Access Compliance Report Public Rights-of-Way (Curb Ramps)

Main Street: N/A Cross Street: CERRITOS_AVE Location: N

ADA ID: RPRK220221120517 Ramp Type: Type 6 - Directional 1 Initial Pass/Fail: Pass Overall Compliance: No Severity Score: 2

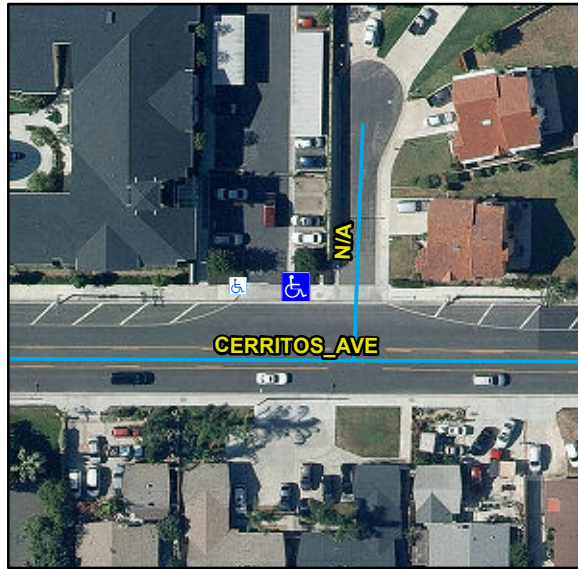
Compliance	Description	Data	Compliance	Description	Data
N/A	Ramp Length (in)	88	Yes	Flare Type LT	
Yes	Ramp Width (in)	48			Curbed2
Yes	Ramp Run Slope (%)	4.6	N/A	Flare Slope LT (%)	N/A
Yes	Ramp Cross Slope (%)	0.5	N/A	Flare Traversable LT	N/A
Yes	Grade Break	Yes	No	Flare Type RT	
Yes	Grade Break Slope (%)	2.7			Curbed1
Yes	Grade Break Cross Slope (%)	1.1	N/A	Flare Slope RT (%)	N/A
	Addl Para Ramp Left?	No	N/A	Flare Traversable RT	N/A
	Addl Para Ramp Right?	No	Yes	DWS Provided	Yes
N/A	Landing Present	Yes	Yes	DWS Contrast	Yes
Yes	Landing Length (in)	52	Yes	DWS Length (in)	36
Yes	Landing Width (in)	89	Yes	DWS Full Width	Yes
Yes	Landing Run Slope (%)	0.3		DWS Offset Type	Multiple
Yes	Landing Cross Slope (%)	0.6	Yes	DWS Left Offset (in)	12
N/A	Landing Movement Obstructed?	No	Yes	DWS Right Offset (in)	0
	Landing Movement Type	N/A			
N/A	Landing Shared	No			
N/A	Marked Crosswalk 1	No	N/A	Clear Space	N/A
	Crossing 1 Direction	W	N/A	Clear Space To Crosswalk (in)	N/A

Remove & Replace Curbed Edge.

R304.2.3, STD 1115
